BID/ RFP ADDENDUM No.2
DATE: 08/16/2023
BID/RFP No: 2022-19
BID NAME: Vocational Building Remodel

ADDENDUM NO. 02

CAREER TECHNICAL EDUCATION BUILDING RENOVATION
Merced, CA

The following additions, deletions, and revisions to the SHEETS and Project Manual are hereby made and do become a part of these Contract Documents.

AD2-MX06

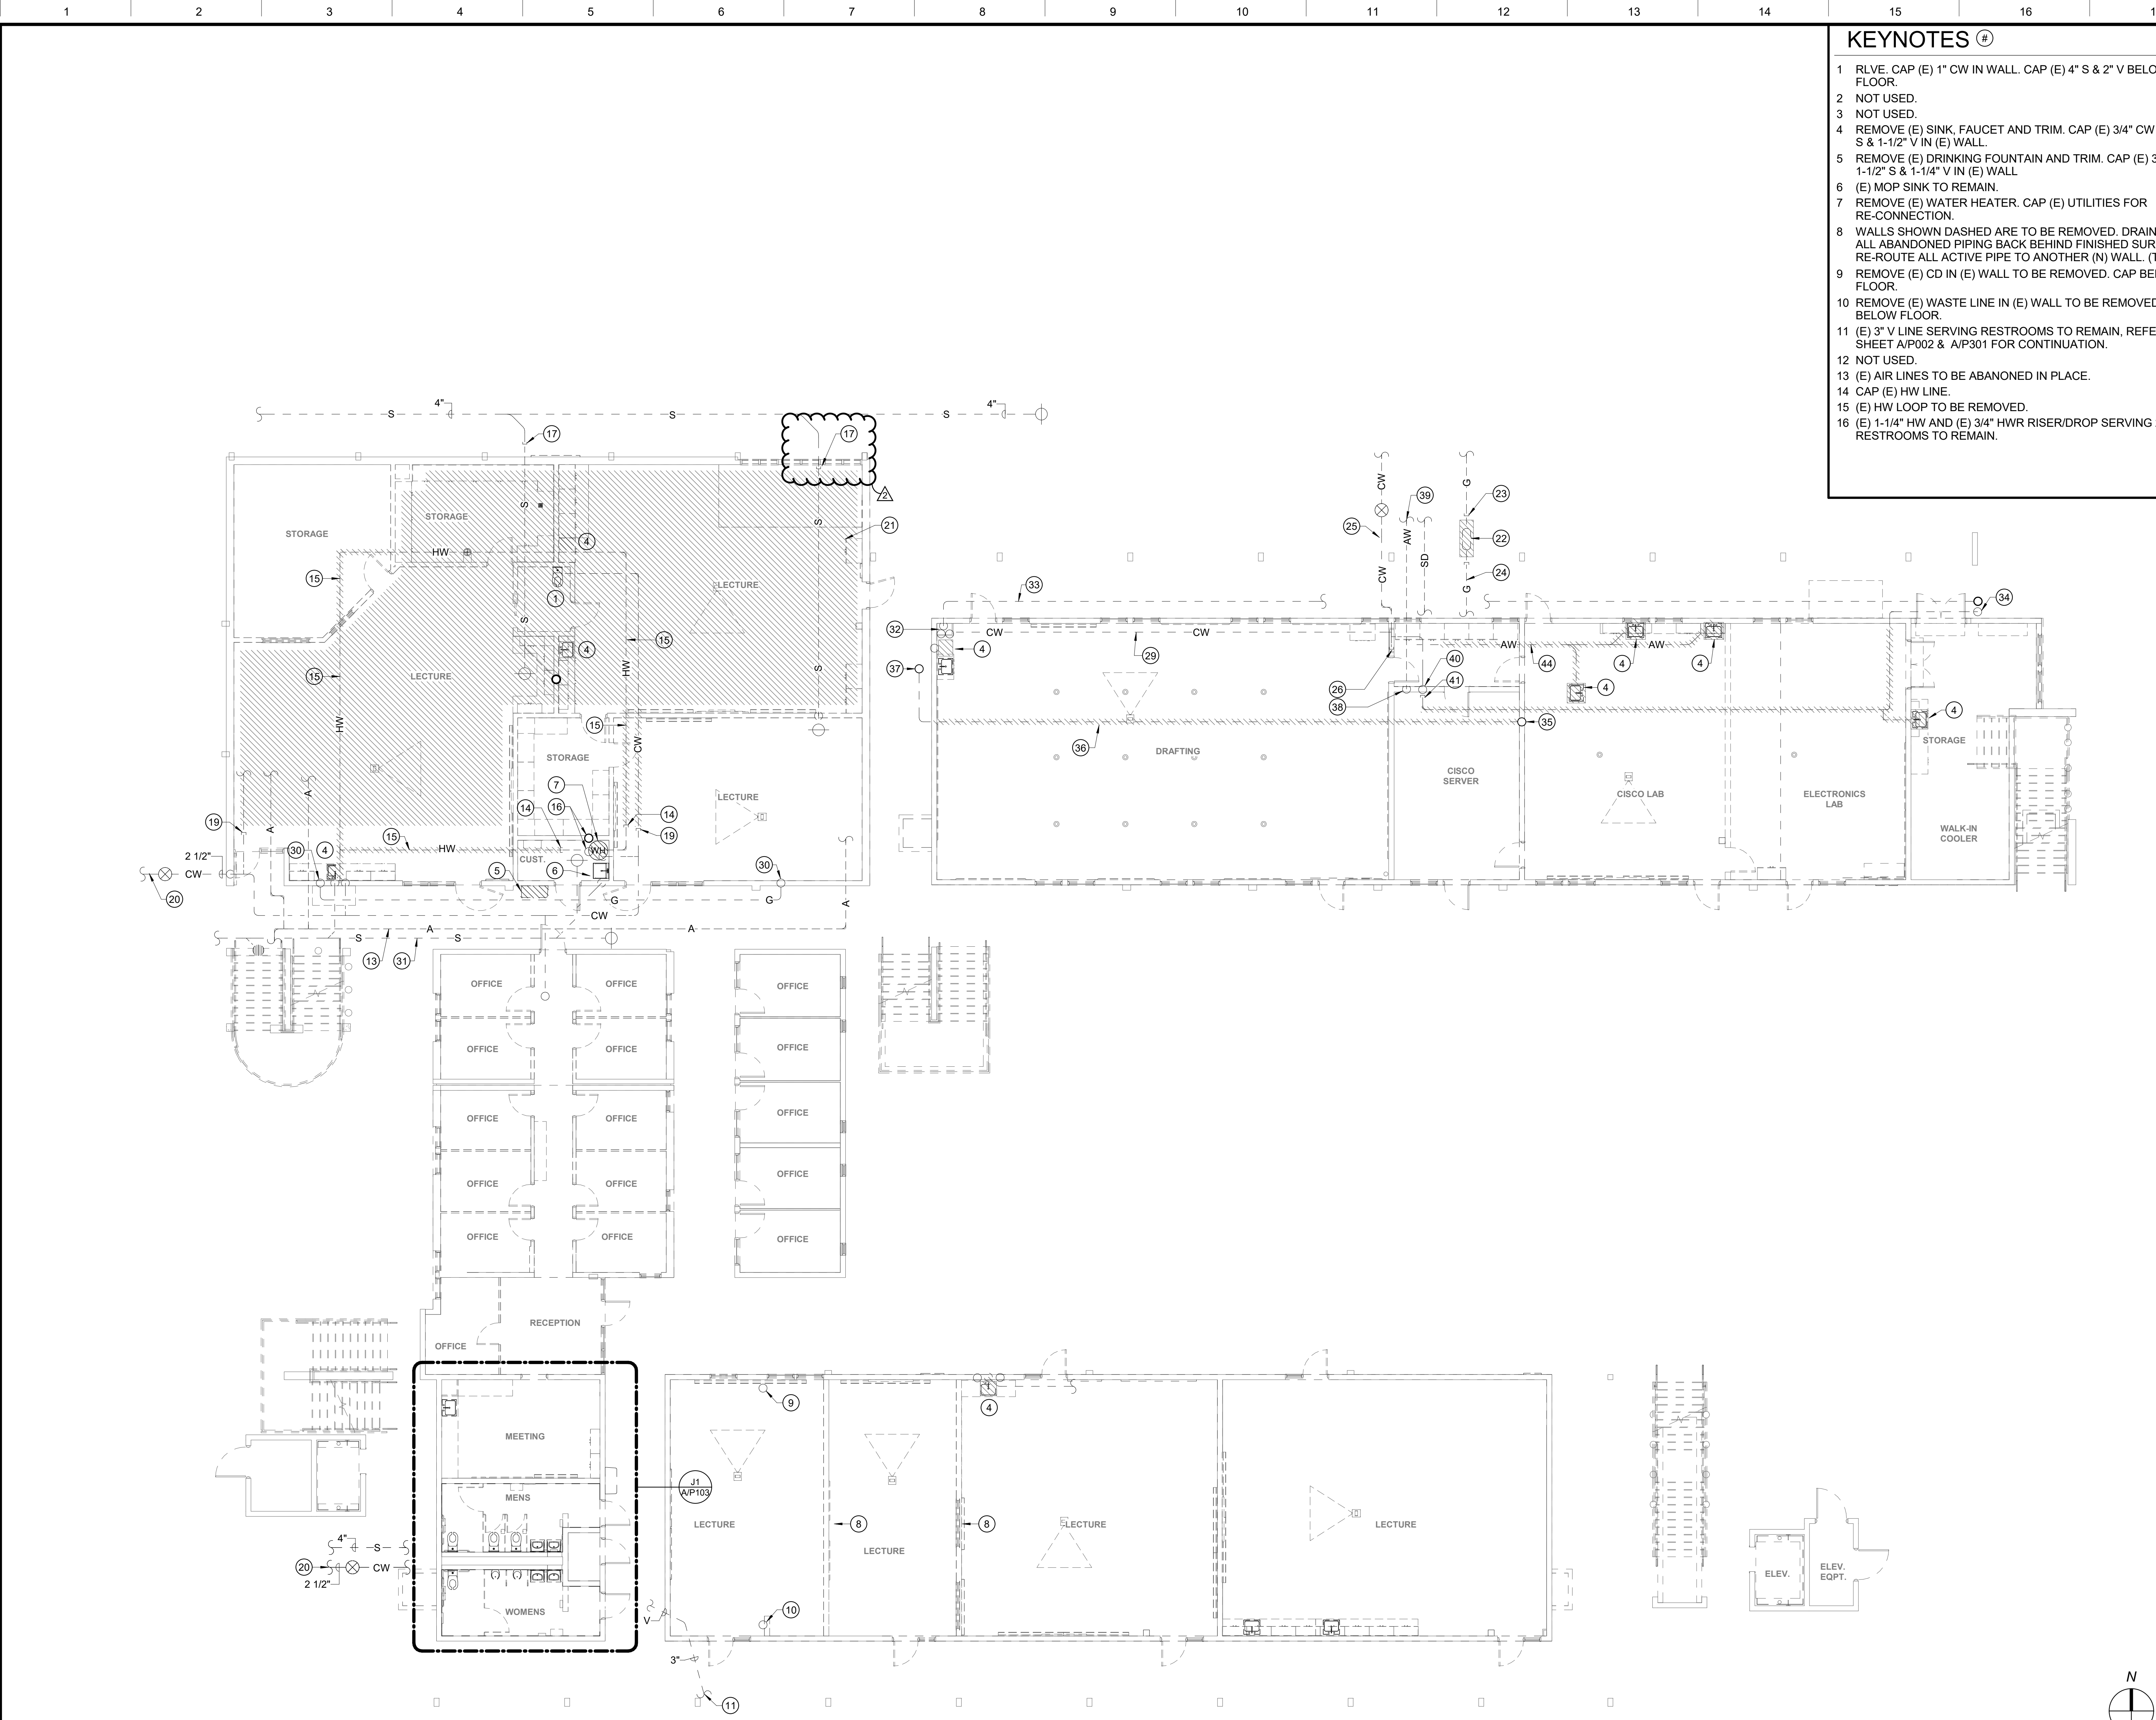
AD2-M06 Refer to Sheet A/M301, MECHANICAL ROOF PLAN:

1. Replace sheet with attached sheet A/M301 MECHANICAL ROOF PLAN with AD2-MX06 in the lower right corner. Changes are in the clouded area(s).

AD2-PX01

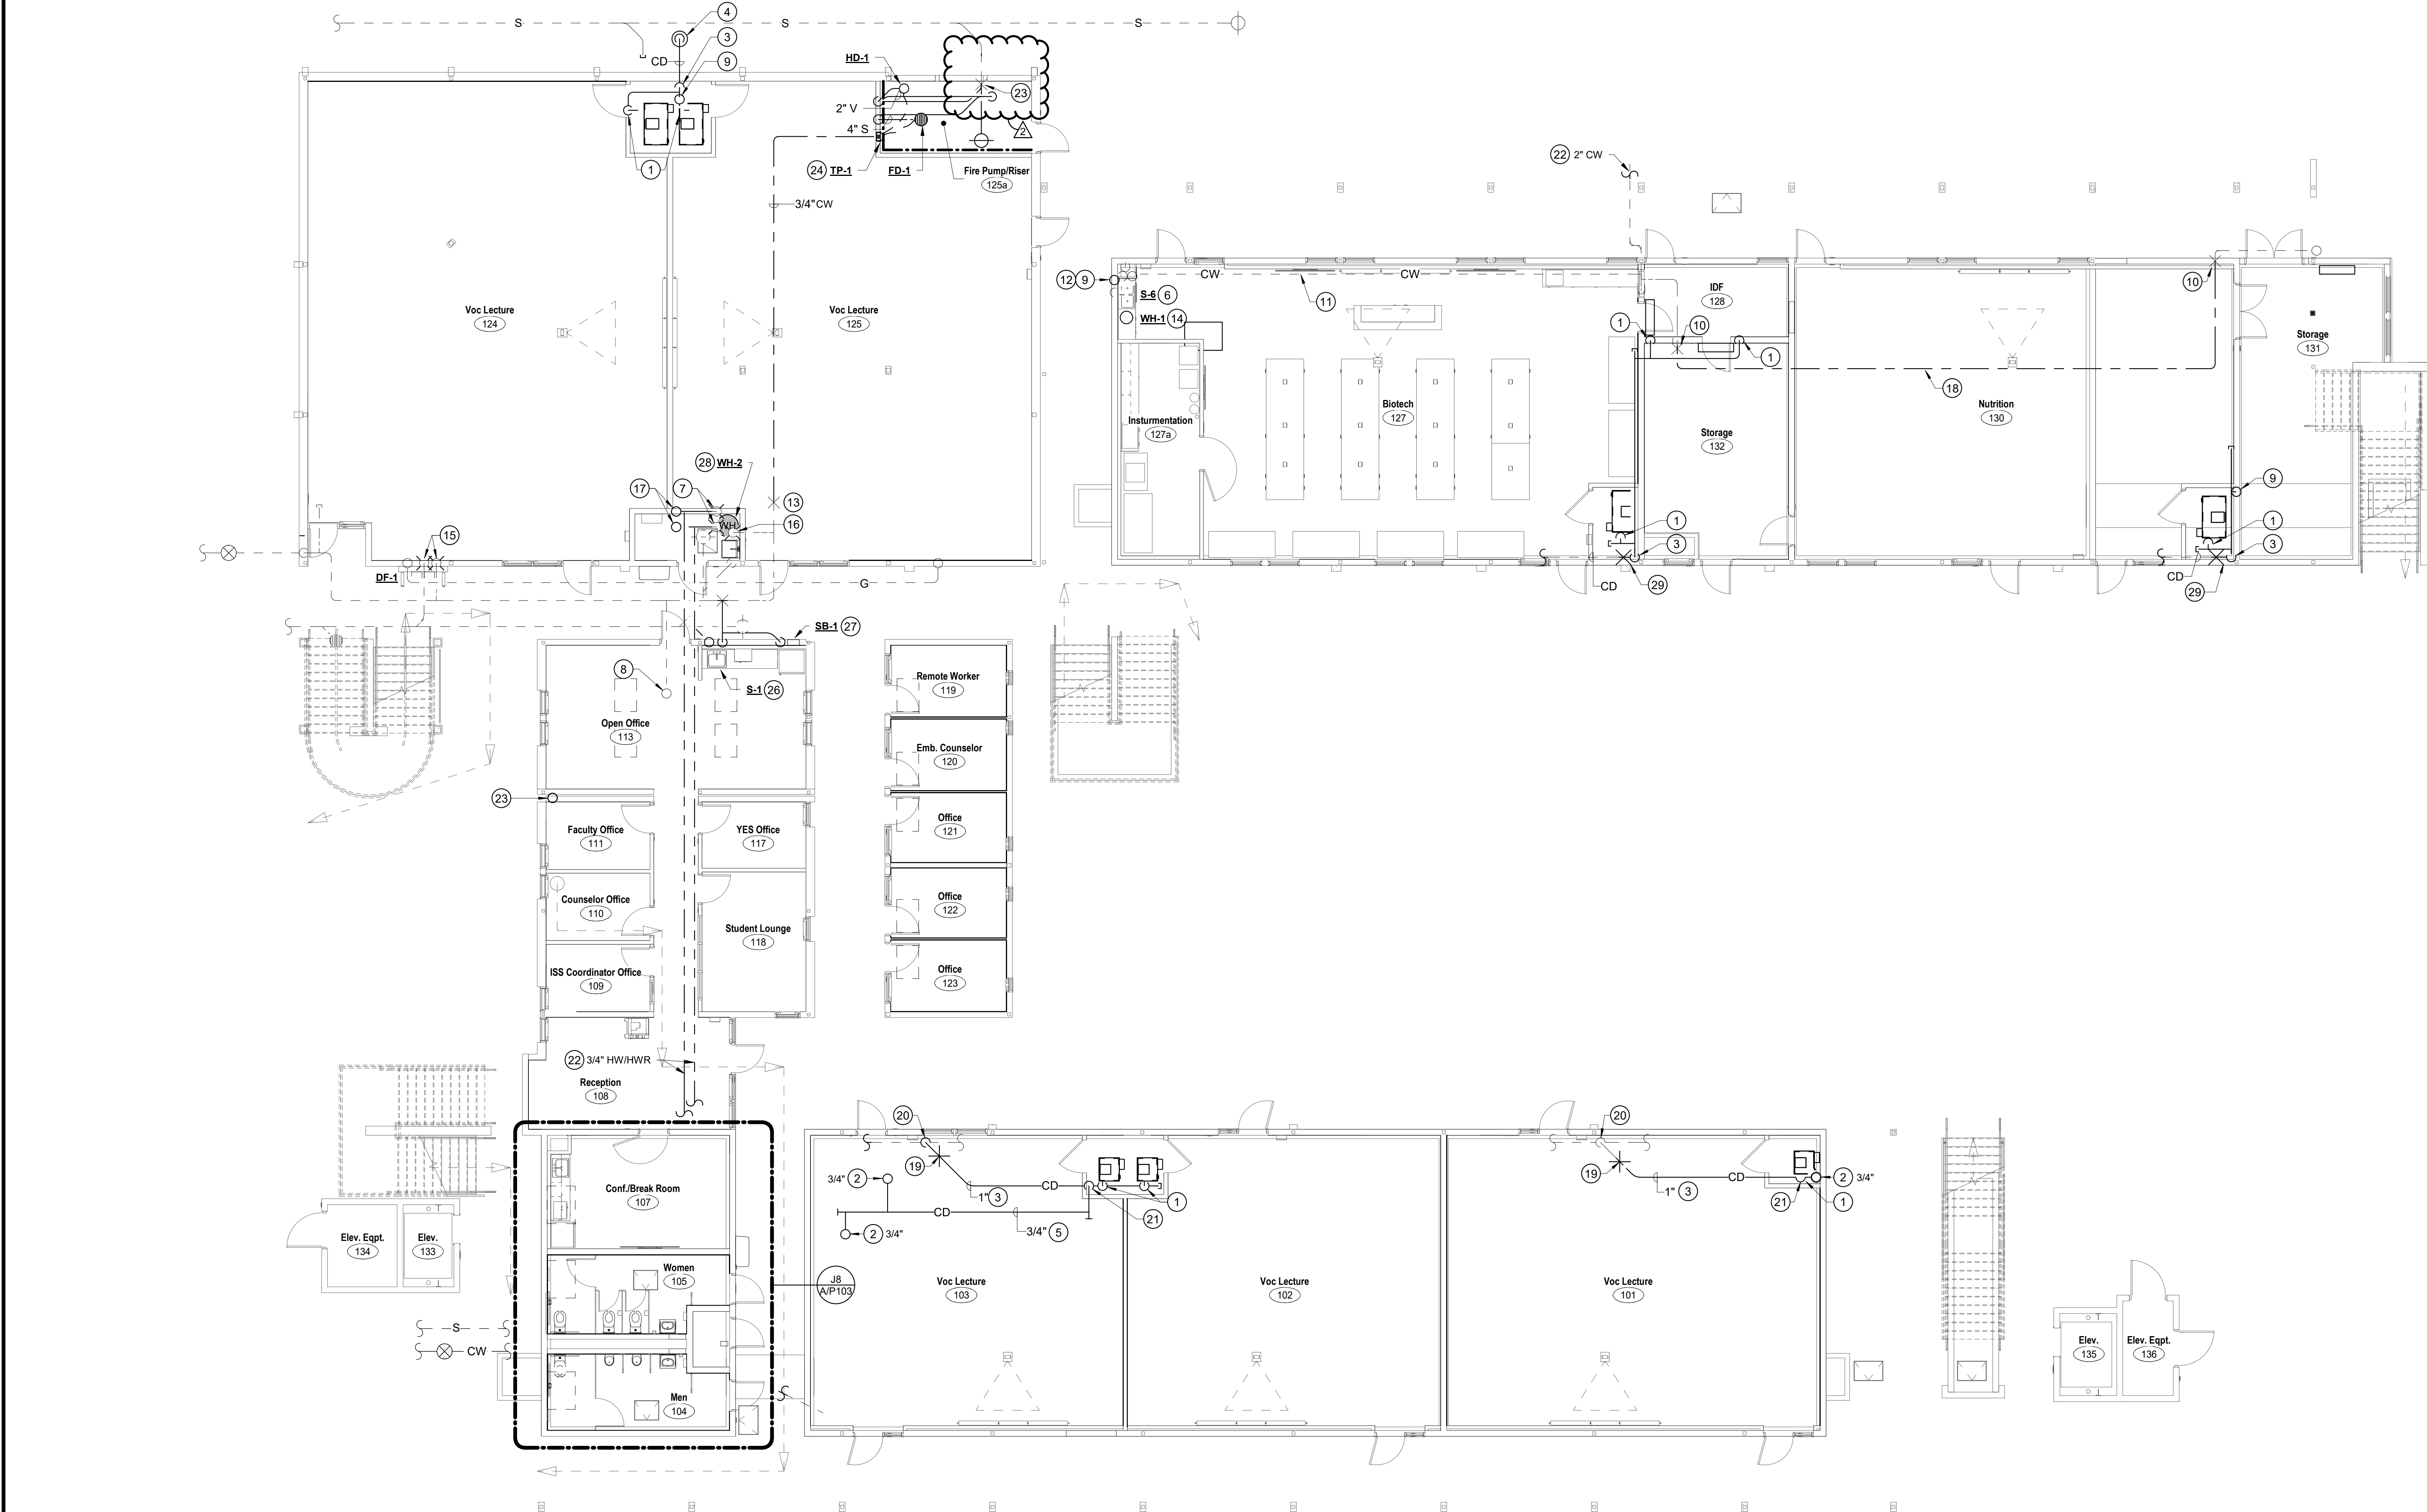
AD2-P01 Refer to Sheet A/P001, PLUMBING DEMOLITION PLAN – FIRST FLOOR:

1. Replace sheet with attached sheet A/P001 PLUMBING DEMOLITION PLAN – FIRST FLOOR with AD2-PX01 in the lower right corner. Changes are in the clouded area(s).
